EDG #1 Summary:

EDG #2 Goal:

the eight one five pine

815 Pine Street
Denny Triangle Urban Center Village
DPD Project # 3007151

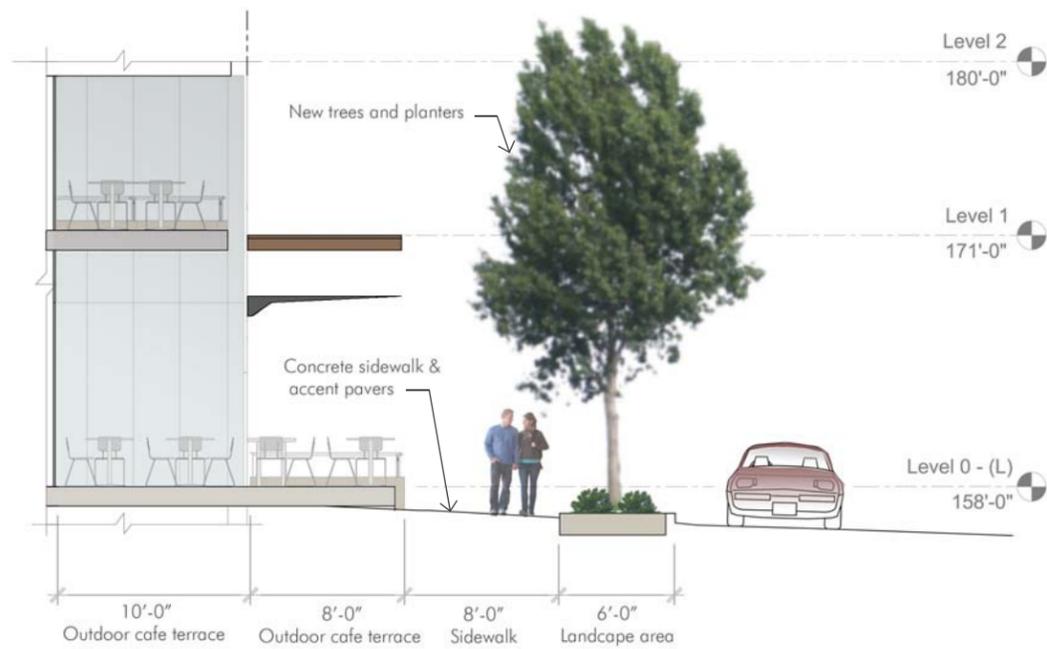
EDG #1 Guidance – The board urges the applicant to design a more welcoming entry.

Response – The primary building entrance was moved to Pine Street to highlight its importance. The entrance is slightly recessed to create a shadow reveal and will be distinguished with a different canopy design and greater copper/bronze details than the adjacent restaurant & retail entrances.

Section A @ Pine Street cafe terrace

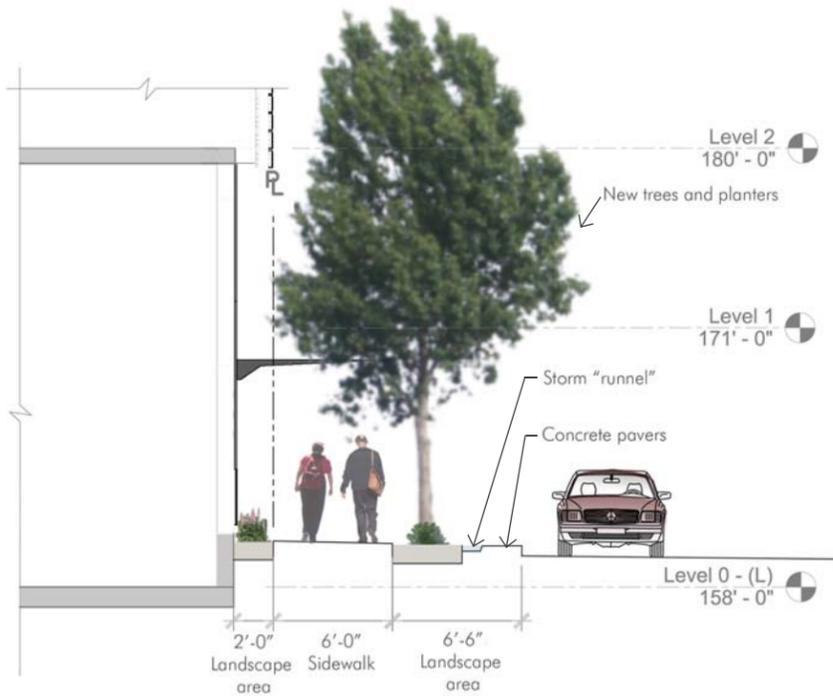
EDG #1 Guidance – “...the design should recognize the greater visibility (of the corner) by wrapping the materials and fenestration from the north façade to the alley.”

Response – The distinctive channel glass parking screen is wrapped around the corner of Pine Street at the alley and terminated with a tall grove of black bamboo. A large landscaped ‘green wall’ is proposed for the entire alley façade that will completely screen all parking levels from residential units. This green wall is designed as an 8’ long steel trough with an integrated vertical trellis system that will allow it to be grown in a nursery concurrent with construction and installed fully mature. The trough will be easily accessible to allow for reliable health and maintenance. A mix of ivy types is proposed to provide a subtle color variation with even planar texture as well as complement the similar landscaping of the adjacent Convention Center. The green wall is also consistent with the overall concept of the western private side of the building and echoed with similar landscaping on the 6th and rooftop amenity levels.

Alternate massing

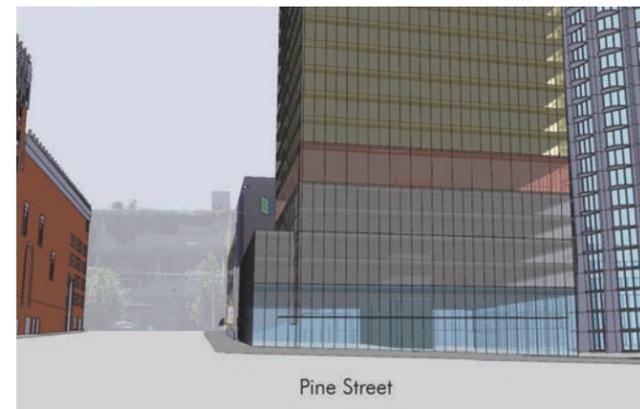
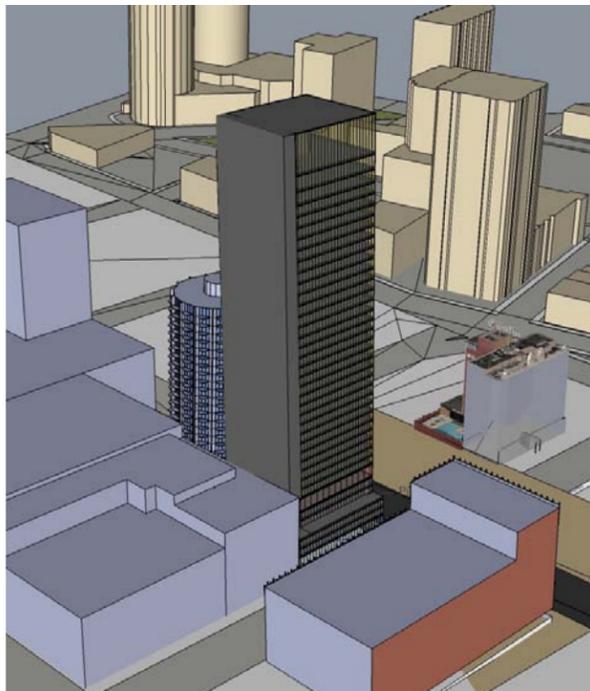
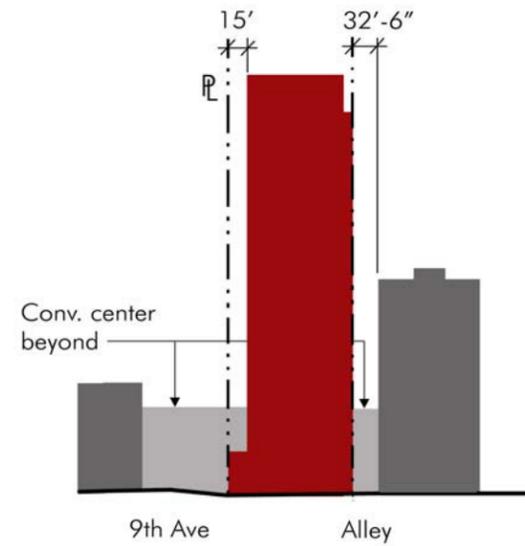
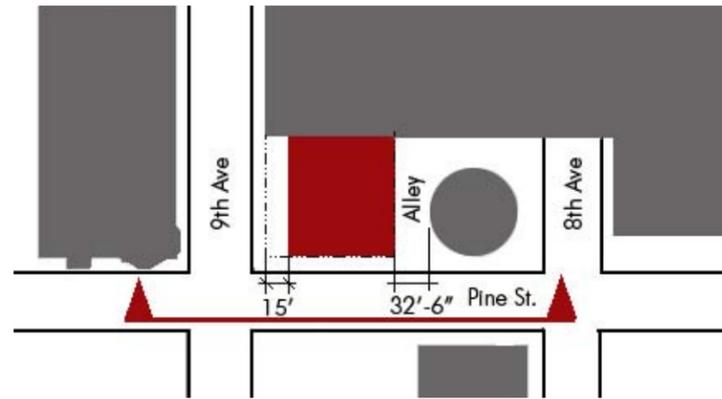
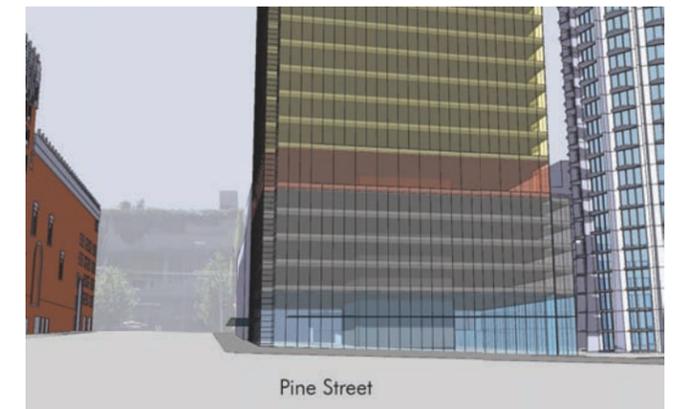
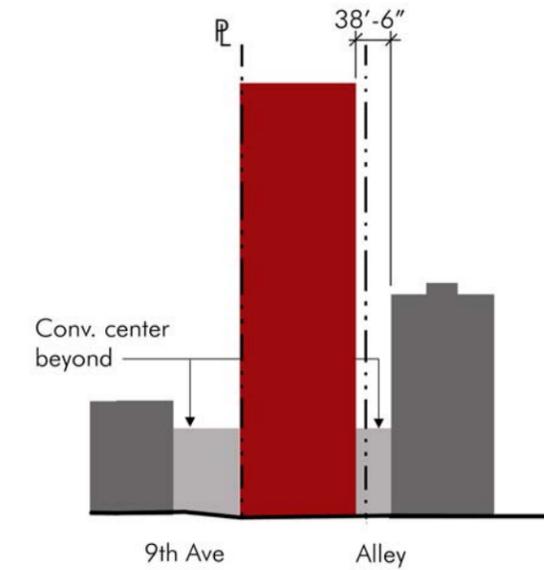
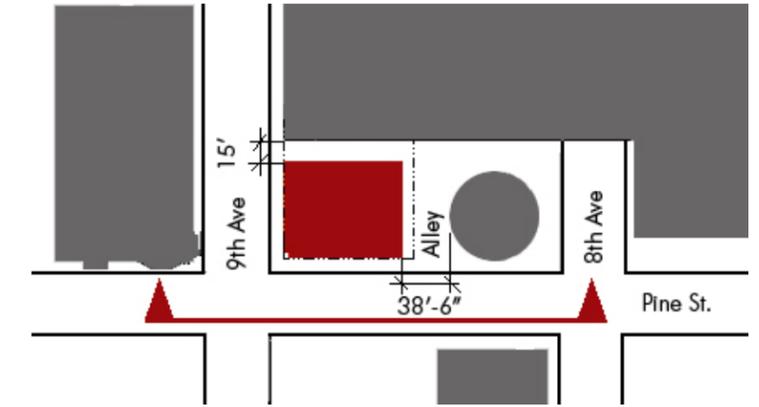
Code Section - SMC 23.49.058 F2 (Downtown Office Core 1, Downtown Office Core 2, and Downtown Mixed Commercial upper level development standards).

Requirement - When a lot in a DMC or DOC2 zone is located on a designated green street, a continuous upper-level setback of 15 feet shall be provided on the street frontage abutting the green street at a height of 45'.

Proposal - The design concept proposes tower setbacks on two sides, one along alley elevation adjacent the existing residential tower and the other adjacent the Convention Center, in lieu of the single 9th Avenue setback.

Rational - The primary design concept establishes a 'strong corner' at the intersection of Pine Street and Ninth Avenue as a specific and contextual response to this unique location in the city. The concept also complements the predominant street wall heights on both streets as well as maximizing the tower separation adjacent the neighboring 801 Pine residential tower. Other reasons for providing the two setbacks include:

- Avoiding a 400' blank 'party' wall adjacent the Convention Center (as would be required to maximize development capacity)
- Potential view corridor, canyon or shadow protections are not significant and/or applicable to this location.
- Overall bulk and massing for residential buildings is already controlled by the 10,700 SF floor plate limits that do not exist for office buildings. See illustrations on page 5.1 and 5.2.
